COUNTY OF SAN MATEO
PLANNING AND BUILDING DEPARTMENT

DATE: May 27, 2009

TO: Planning Commission

County File Number: PLN 2005-00603 (Ehteshami)

Drawing 2:
Any failures of the catch basin system and cause water to flow on to our property to creek.

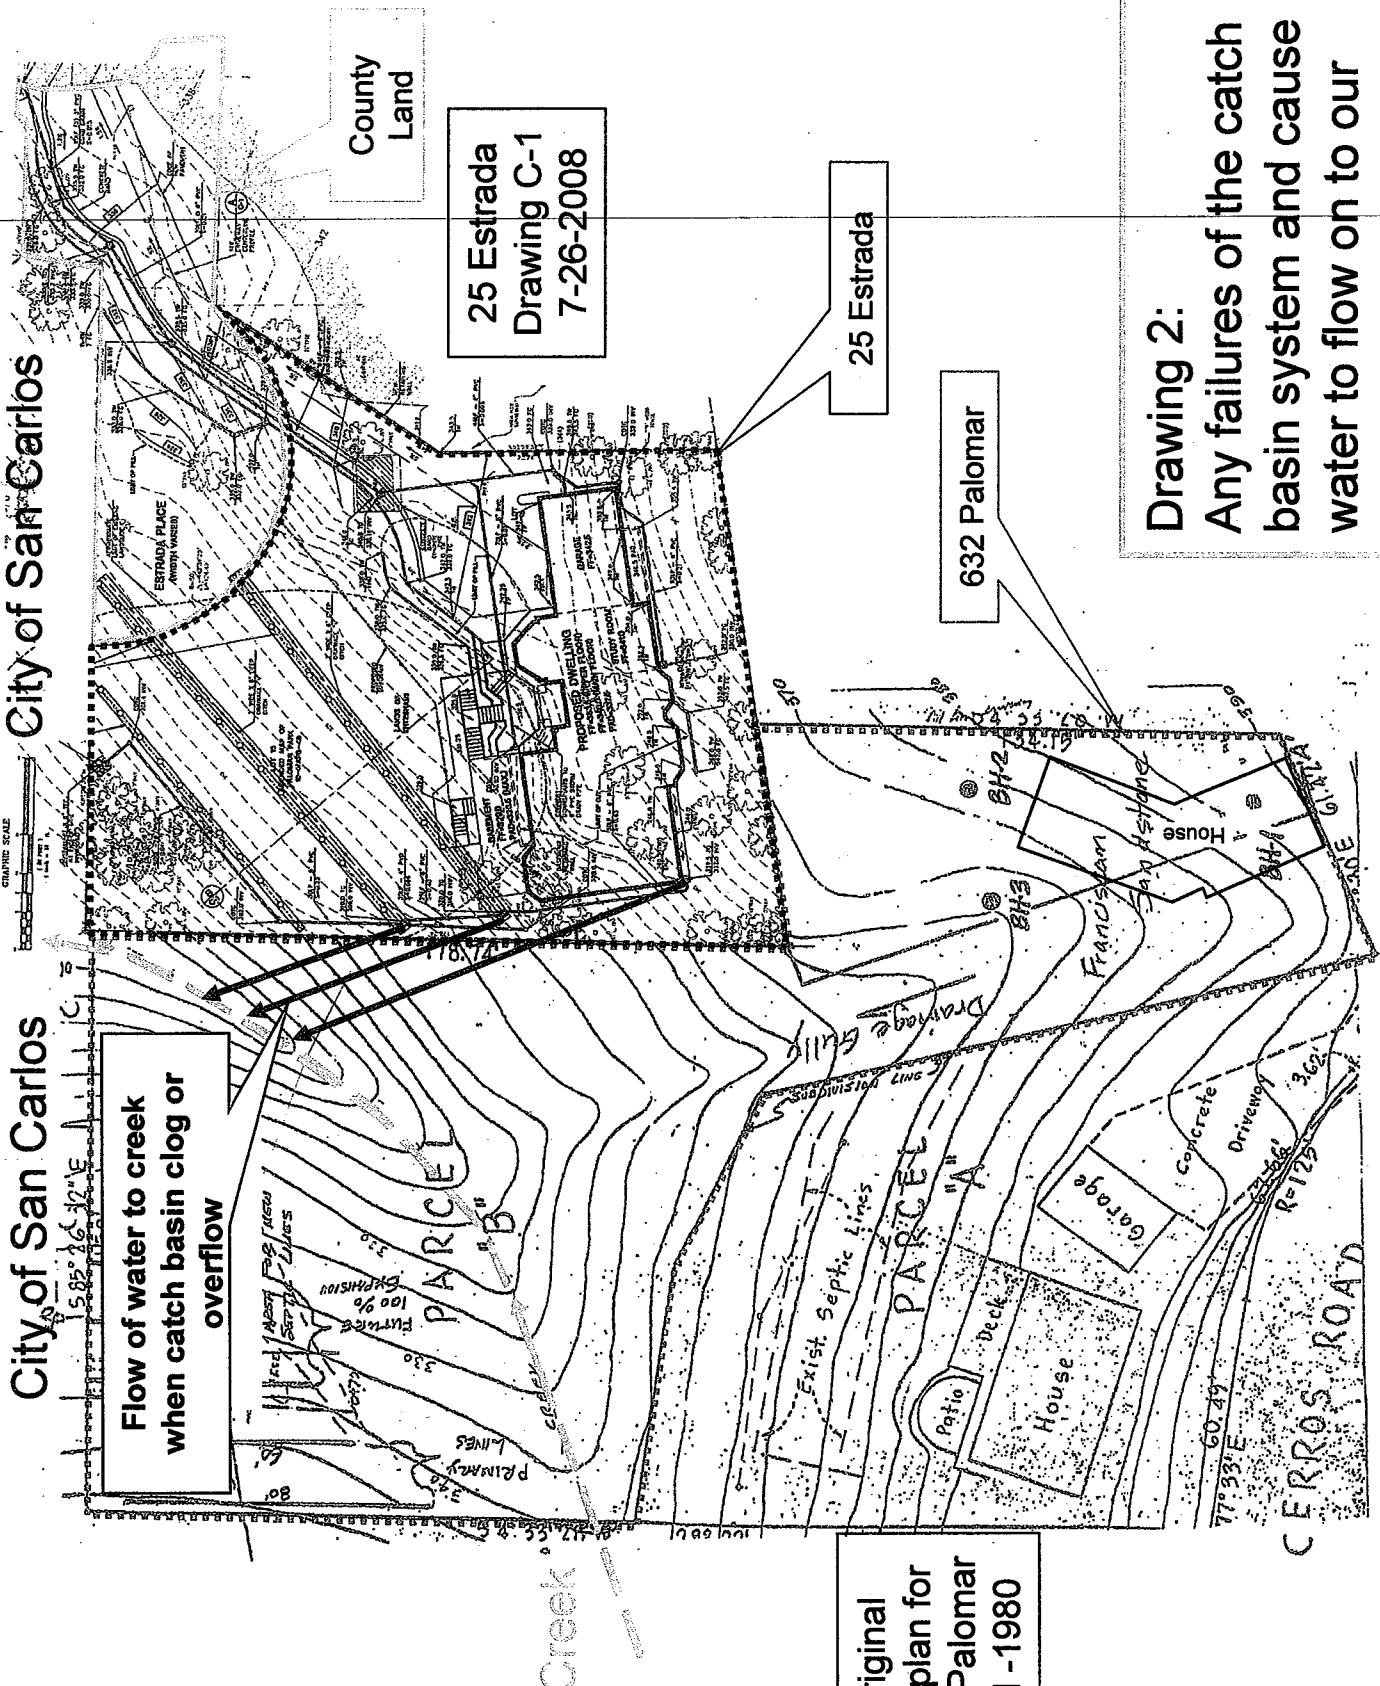
- b) In the case log on the web site, Ms Demouthe asked for more data on what was downhill of the leach field and dissipater. Drawing 2 provides a rough indication of how our lot and 25 Estrada topology meet. Our property and the property of the City of San Carlos are below the proposed leach field. The dissipater, in its current location, will effect the City of San Carlos, but given its location and the topology, it is not clear what impact the dissipater will have on us.

Flow of water to creek when catch basin clog or overflow

Drawing 3:
Trenching for Leach lines

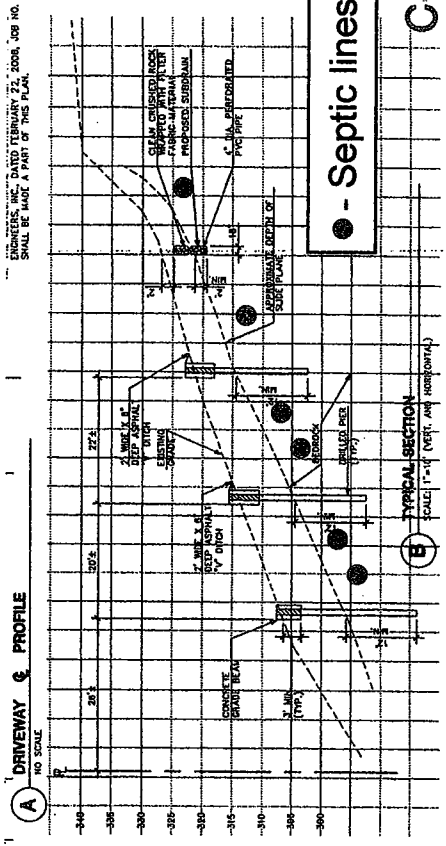
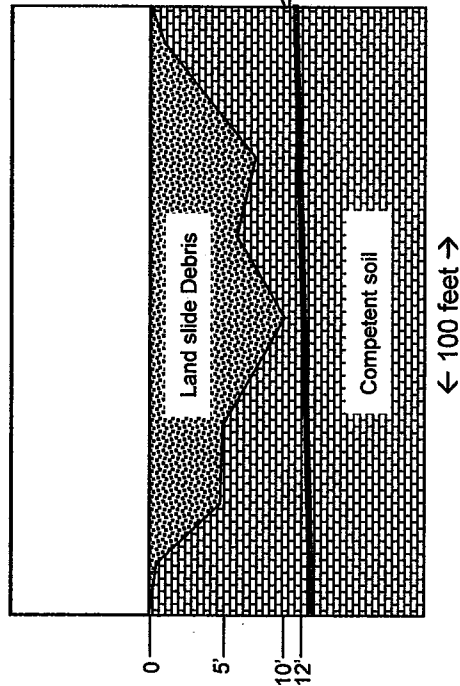
- The leach lines must be placed in competent soil. The entire length of each leach line will have to be dug below the lowest depth of slide debris encountered anywhere along that line— Drawing 3. According to Romig's soil borings and typical cross sections on C-1, the leach lines will have to be trenched across the face of the slope to a depth of:
 - ~12 feet for the lowest 2 lines,
 - ~10 feet for the middle 2 lines,
 - ~7 for the upper 2 lines.

Drawing C1 with approximate placement of septic lines from Romig Figure 7 March 2008

Example of trenching requirements

- Septic lines need to be placed 2-3" into competent soil below debris
- Septic are installed with gentle slope of 1/8" to 1/4" per linear foot
